A review of a Crowd Safety Options Appraisal undertaken for  
Tottenham Hotspur Athletic Football Club Ltd.

Dr J F Dickie  
October 9<sup>th</sup> 2015

# Tottenham Hotspur Football Club - Crowd Safety Options Appraisal, [3]

Fig.2. Typical video data as interrogated by Movement Strategies.

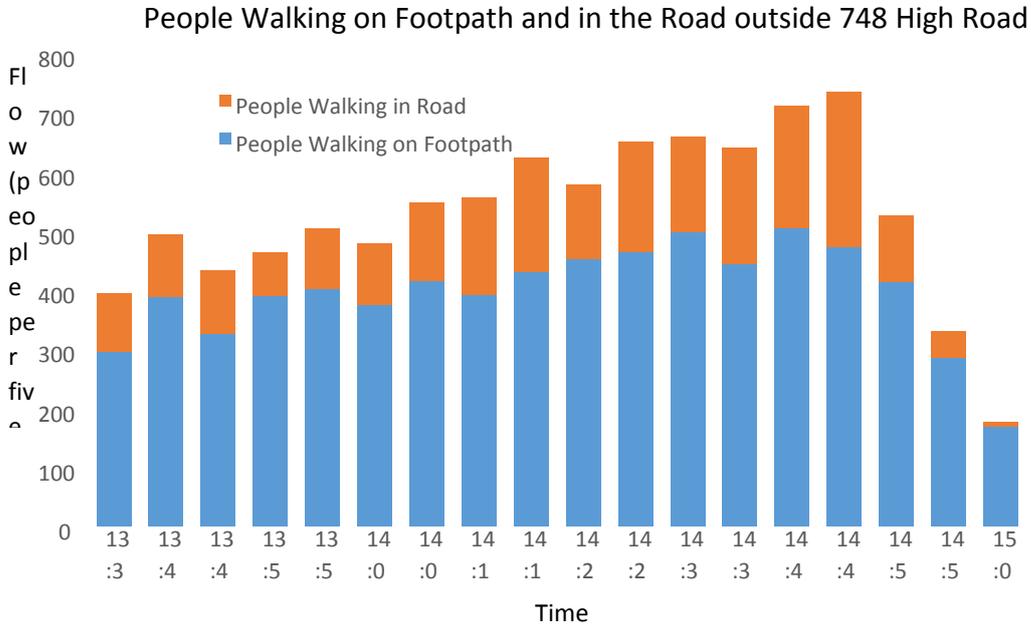
Where bulk arrivals from train and tube stations are present in a crowd flow the adoption of a five minute interval can mask their presence. The observed capacity of the walkway (effective width 1.8m in front of 748 High Road) appears to be approximately 100 persons/minute which equates to 55 persons/metre/minute, lower than might be assumed.

Fig.2 also informs that for 90min prior to match kick-off significant numbers of persons walk in the road.

Fig.3 Surveyed Movements at 748 High Road (2.2m wide)[3].

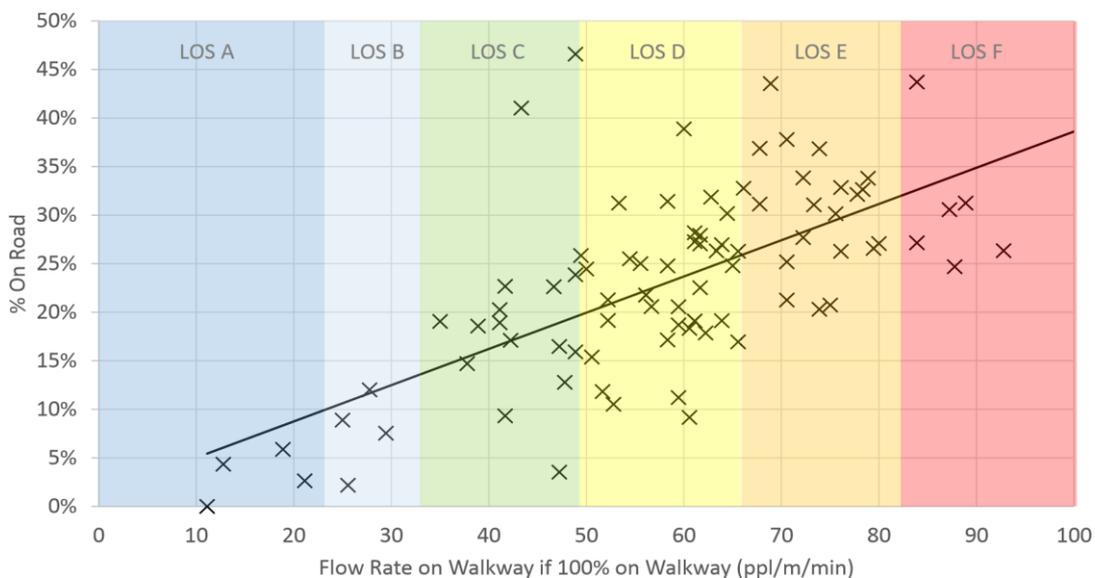
A hypothetical flow rate at each location was derived by summing both elements of flow (on-walkway + on-road) and dividing by the walkway width at each location. Fig.3 illustrates data from surveys outside of 748 High Road. Similar graphs are presented for 750 High Road and a location north of Paxton Road. As would be expected the walkway widths at the locations were reflected in the percentages observed walking in the road. The results from video surveys established that:

The scatter about the trend line reflects the nature of the flow. In a uniform flow scatter would not be present in the observed data. The scatter is indicative of a variable density and slower moving groups. The presence of persons walking in the road at very low densities is important. A flow rate of 10 persons/metre/min equates to 10 persons walking in single file **6m** apart with a walking speed of 1m/s. The average walking speed is normally about 1.4m/s

The presence of persons walking in the road at such low densities indicate to this writer that should an individual choose to step into the road to avoid conflict he or she will not necessarily elect to step back onto the walkway once the conflict no longer presents itself. A conflict does not mean an actual impact. A conflict is any stopping, changing of direction or breaking of normal walking pace due to a too close confrontation with another pedestrian.

Fig.4. Forecast flows/minute in the consented scheme.[3].

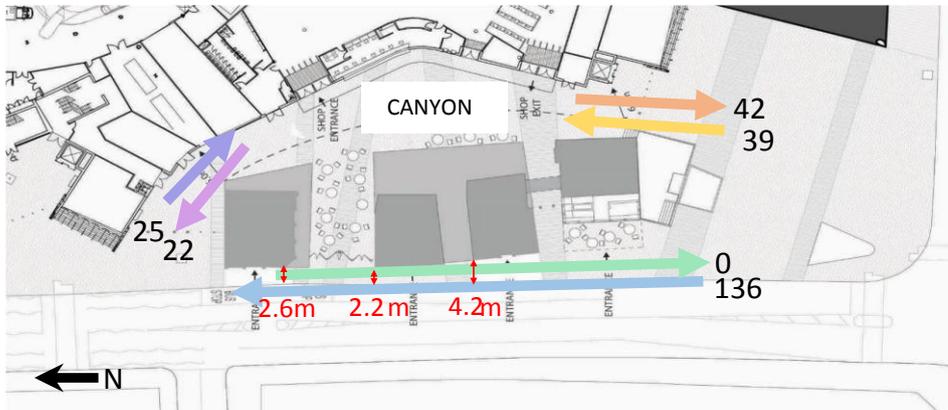
Using the forecast flows illustrated in Fig.4 coupled with the effective widths the predicted flow at the 'pinchpoint' was derived as 76 persons/m/minute. The authors correctly conclude that this is not achievable given the composition of the spectator body and large numbers would inevitably walk in the road. Site data cements this conclusion.

The authors consider the possibility of diverting an element of the flow through the Canyon indicated in Fig.4.

*Fig.5 Typical characteristic of rate of spectator arrivals at a venue from a tube station .*

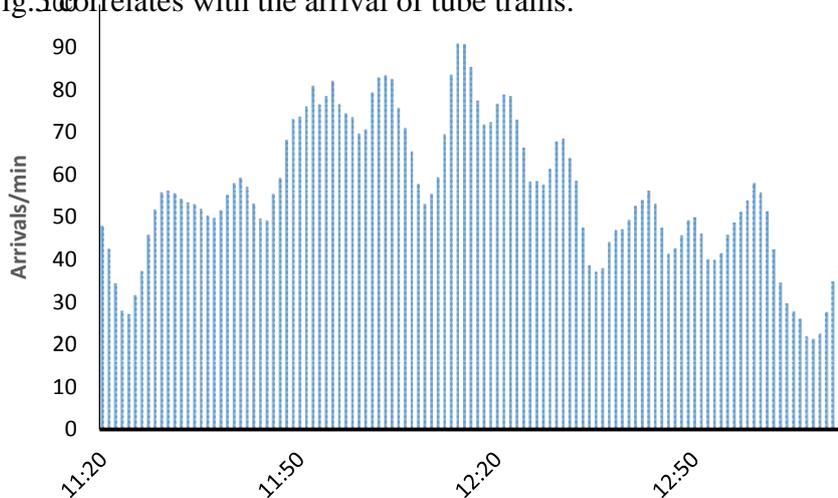
Consider Fig.5 which illustrates data concerning spectator arrivals at a sporting venue walking from a tube station. The tube station was approximately a 15min walk from the venue. The data was obtained using a minute interval count. The skyscraper characteristic evident in Fig.5 correlates with the arrival of tube trains.

This writer is not knowledgeable with regard to modal share of arrivals at THFC however the club website indicates that the walk from Seven Sisters tube station is 20min. Consequently for spectators using the tube there will be an element of bulk arrival. This creates a variable density in the flow in addition to that attributable to social groups.
